EAST SEWERSHED LARGE DIAMETER PACKAGE III
Solicitation Number: CO-00147
SAWS Sewer Job No.: 16-4520

ADDENDUM 2
October 30, 2017

DEVELOPER:			
CONT.		BUDGET PROJ.	
SUBMITTED _____			
APPROVED _____			
MAP No.		SHEET 9	
SECT. No.		JOB No. 16-4520 OF 77	
DR.	CK.

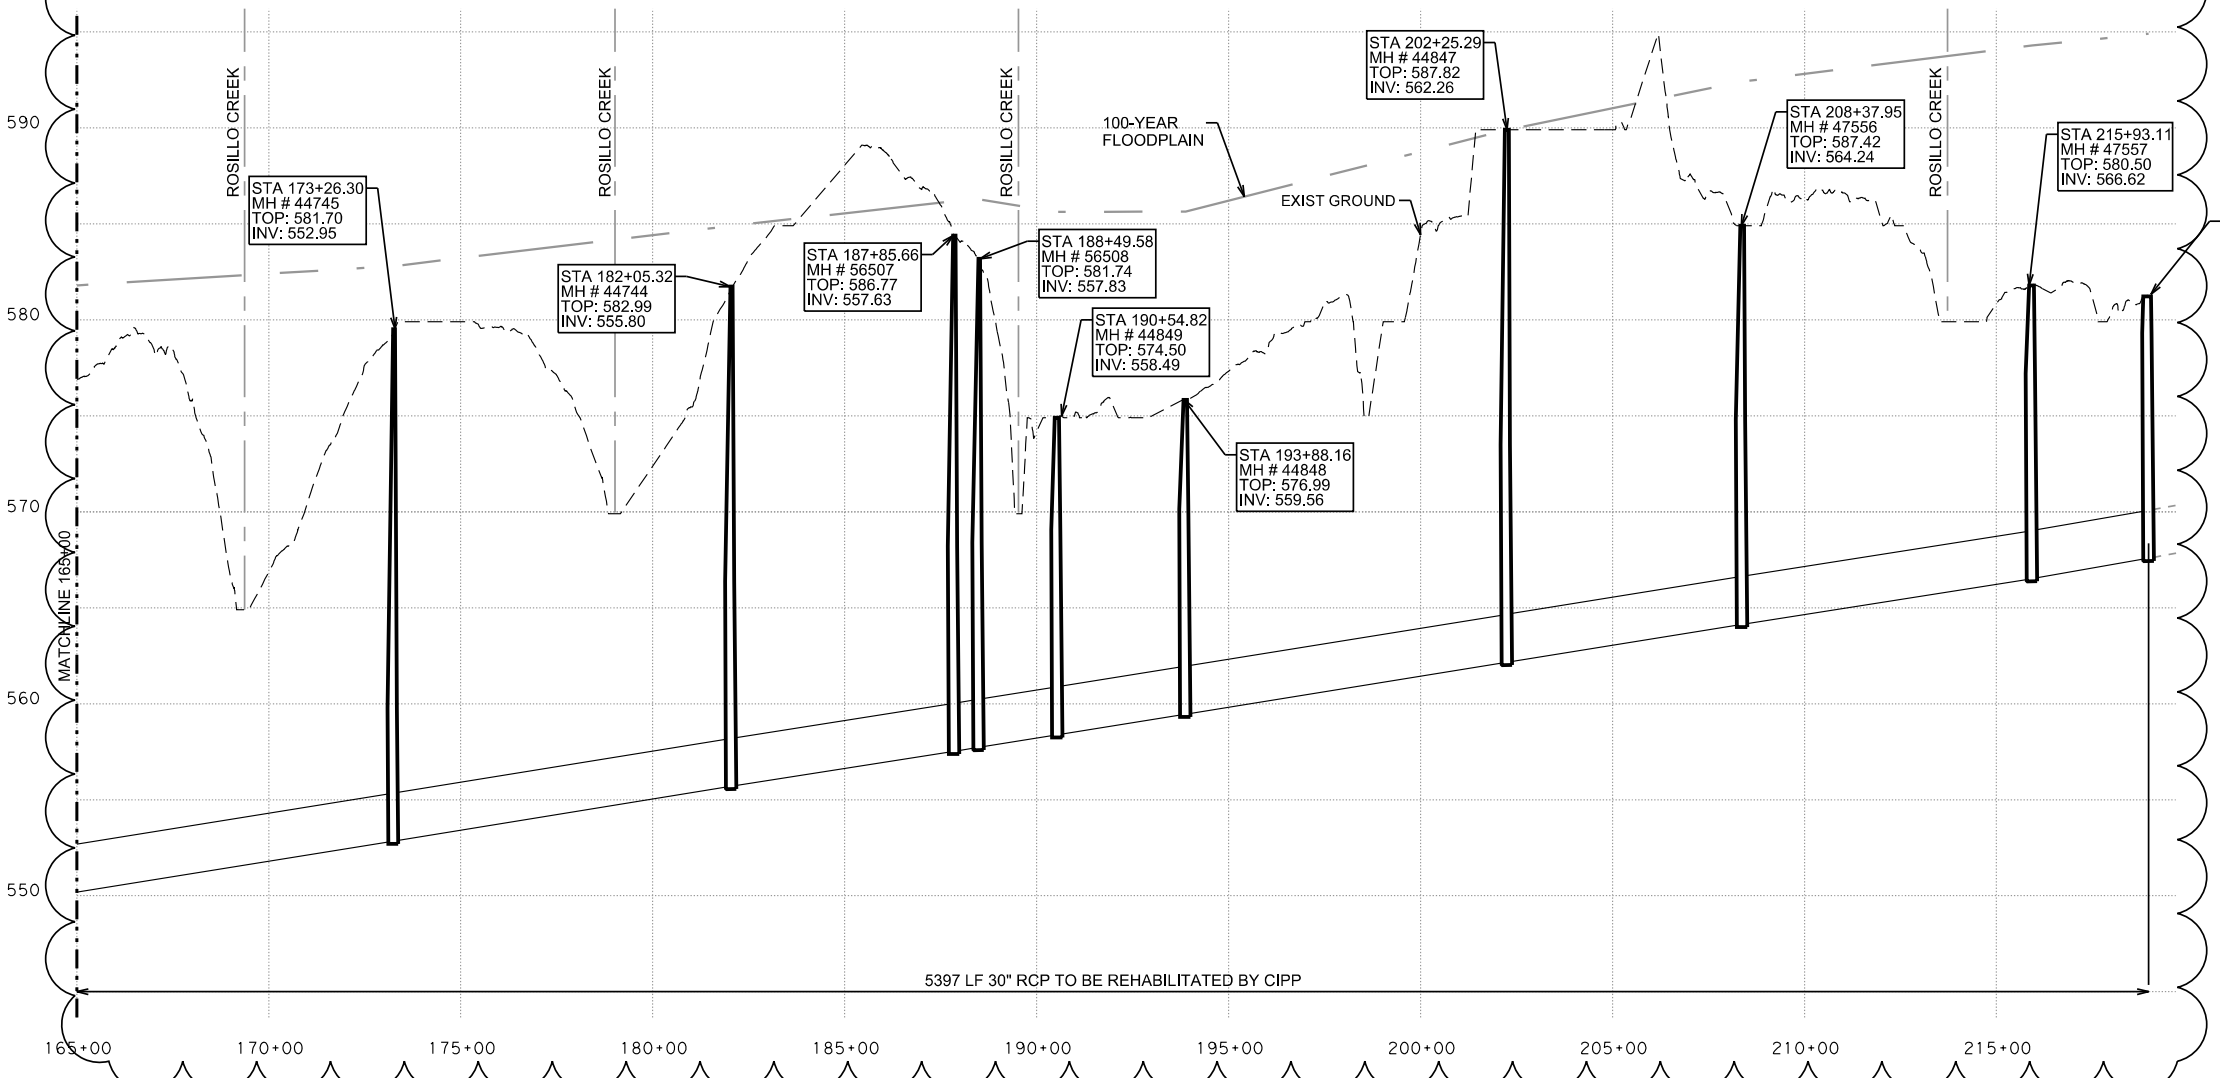
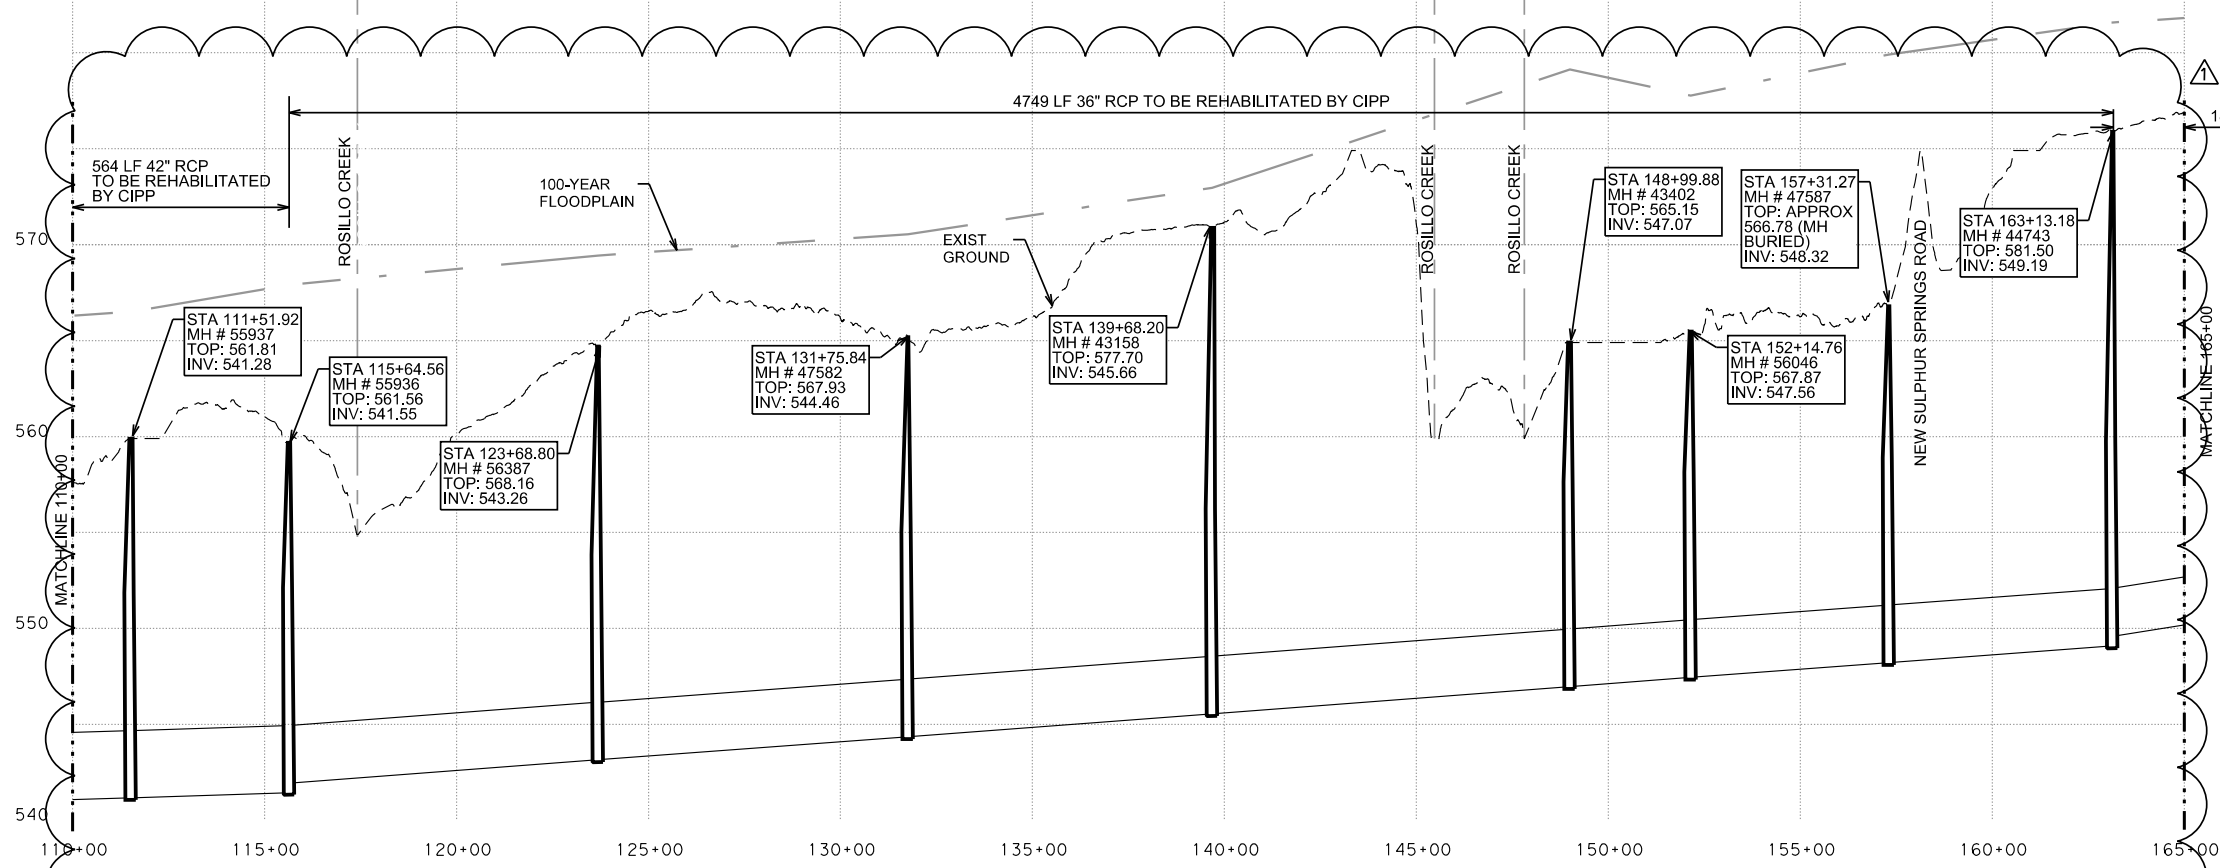
- c. If we will need to use the 100-year floodplain in the CIPP designs, please provide the 100-year floodplain water surface level elevations required to be used as the groundwater level in the CIPP design for any area where the 100-year floodplain will be applicable. Although, the 100-year floodplain is marked on the plan

view drawings, it is not marked on the profiles, and its elevation on the plan views is difficult to determine since the topographical lines are not all marked, and the floodplain does not appear to follow the topographical lines. Unless the 100-year floodplain elevations are provided in a manner that can be tied to the individual sewer segments, it will be difficult, if not impossible, to use the 100-year floodplain levels in the design for the CIPP.

30. There appears to be conflicting elevation data between the profile drawings and the plan view drawings. The stated top & invert elevations on the profiles mostly do not match where the profiles are physically drawn, and often do not match the stated rim and invert elevations on the plan views. In case of conflict between the 3 sources of profile information, which would prevail – the stated tops & inverts on the profiles, the profiles as physically drawn, or the stated rims and inverts on the plan views?

- a. *Soil modulus requirements have been revised. See attached revision to Special Provisions to Specifications Item 901.*
- b. *Groundwater elevation requirements have been revised. See attached revision to Special Provisions to Specifications Item 901.*
- c. *See attached revisions to sheets 9-11.*

Answer: See revised sheets 9-11 issued with this addendum.

DETAIL SHOWING INSTALLATION
OF HINGES OF GATE

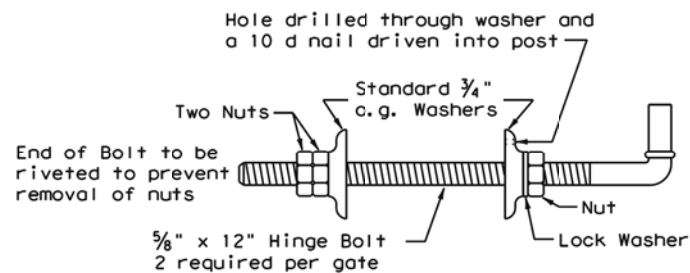
21. Can a pay item be added for temporary livestock fencing? It is uncertain if the property owner will require temporary livestock fencing during construction to protect livestock from the construction area. The contractor should not have to assume that pastures containing livestock or the potential for livestock will all require temporary fencing.

Answer: See attached revisions to bid proposal and special provisions to add temporary livestock fencing.

Gates Furnish materials to the dimensions shown on the plans or as directed. Gates shall be 50” tall (minimum) and shall be utility or farm style. Utility style gates shall be 19 gauge, 1 3/4” tubular steel construction (minimum). Panel style farm gates shall be 5 panel, 22 gauge, galvanized steel construction. Include all hardware such as hinges, chains, and latches as needed to fully operate and secure gate.
